**Planning Application for  
“Temporary Storage of Construction Materials with Ancillary Site Office and  
Associated Filling of Land” for a Period of Three Years  
Lots 469s.ARP(Part) and 469s.BRP(Part) in D.D. 110 and adjoining Government Land  
Pat Heung, Yuen Long, New Territories  
(Planning Application No. A/YL-PH/1104)**

**Response-to-Comments**

**Subject: Application for Certificate of Exemption of Drainage Work**

**DRAINAGE PLAN**

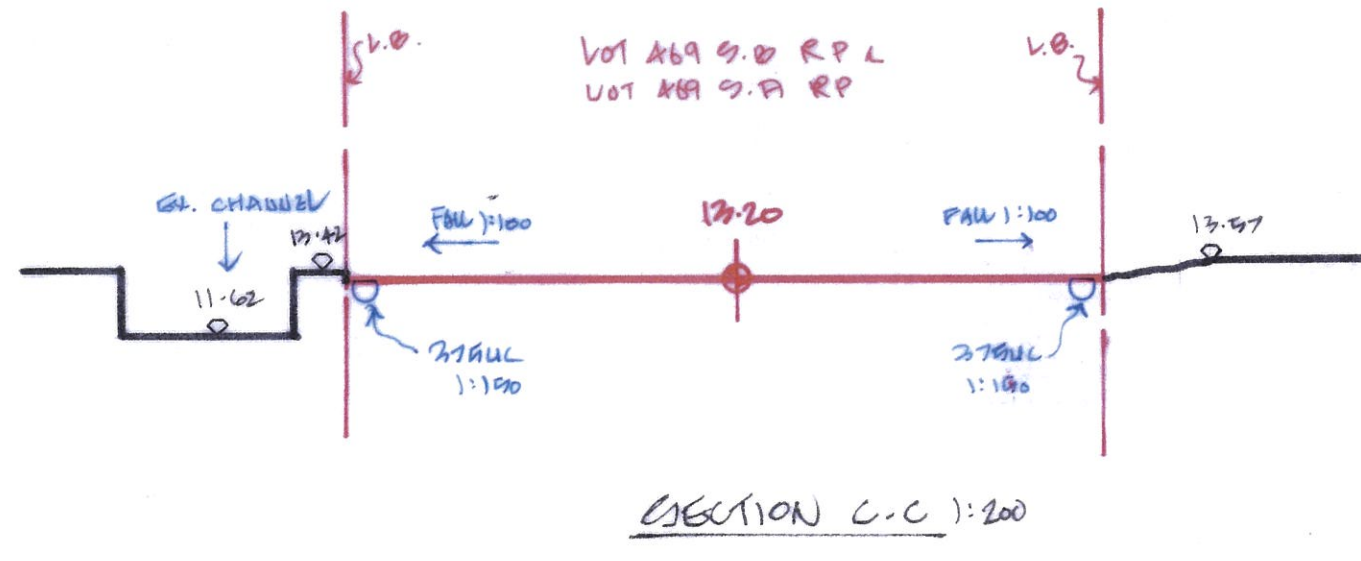
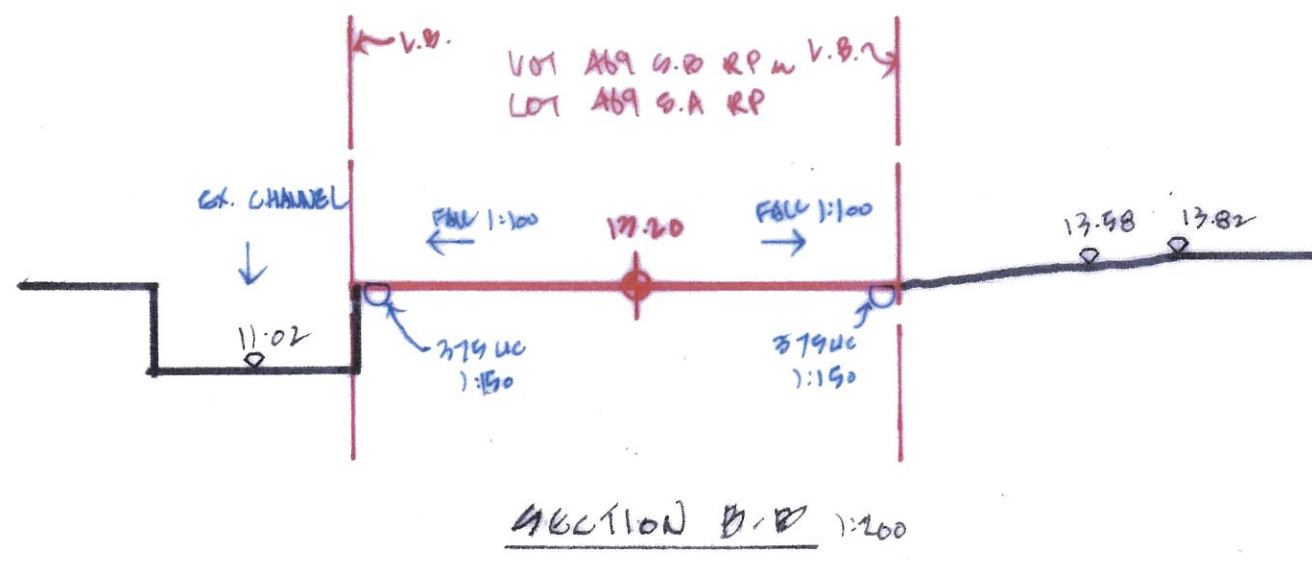
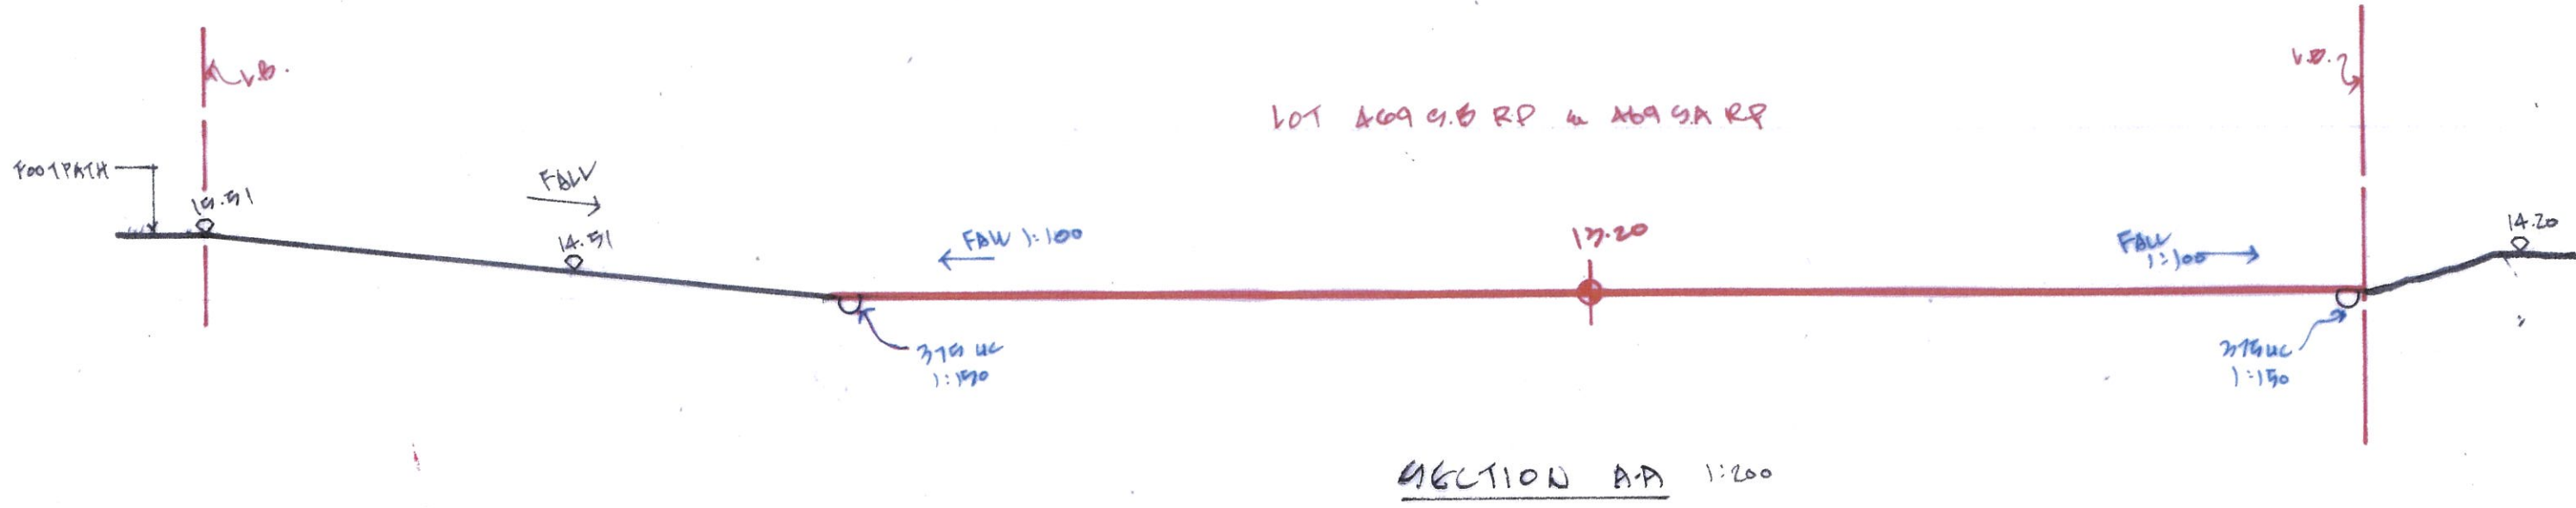
<b>Departmental Comments</b>	<b>Responses</b>
	<b>Drainage Services Department</b>	
(2)	According to our record, there is an existing streamcourse/channel in the adjacent of the application site. The applicant shall be required to place all the proposed works and structures 3m away from the top of the bank of the streamcourse/channel. All the proposed works in the vicinity of the streamcourse/channel should not create any adverse drainage impacts, both during and after construction.	Noted.
(2)	We are unable to provide comment on drainage aspect of the application at this stage. Comment on drainage aspect will be provided when the drainage proposal as mentioned in paragraph 4.7 of the Planning Statement is received.	Please see the attached drainage proposal.

375 C.I. COVER U-CHANNEL (FALL 1:150)

- NEW LEVEL
- EXISTING LEVEL
- CP1, CATCHPIT NO. CP1
- INFALL & OUTFALL LEVEL OF CATCHPIT TO BE THE SAME
